MEMORANDUM

RE: 13558 Mitchells Way
West Friendship, MD 21794
"BP Approval"

RE: 13558 Mitchells Way
West Friendship, MD 21794
"Site Plan"

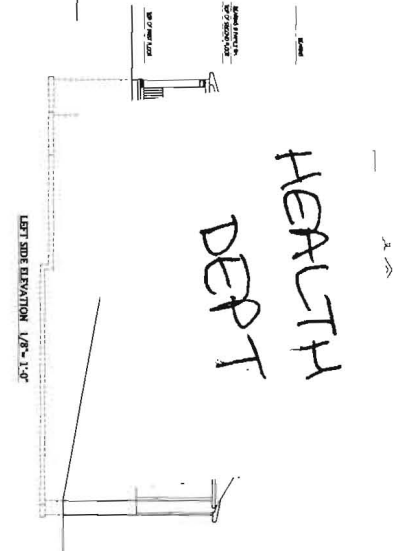
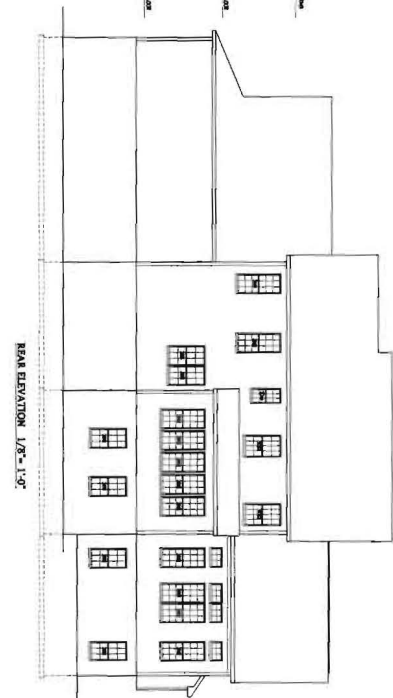
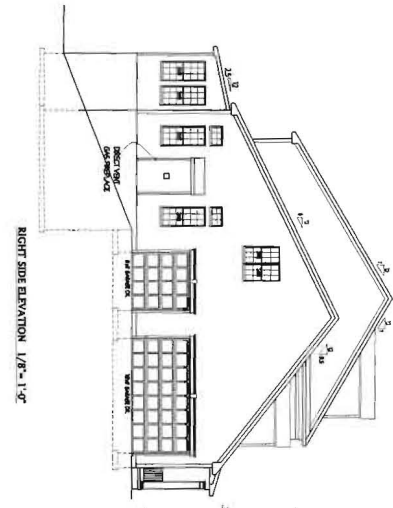
I have reviewed the building permit for 13558 Mitchells Way and here are my comments. The site plan needs to show the depth elevations (ground elevation and invert elevation) of the proposed gravity line. Depth elevations of the house connection point as well as the clean out and septic tank connection points need to be shown. The diameter of the gravity line also must be included on the site plan.
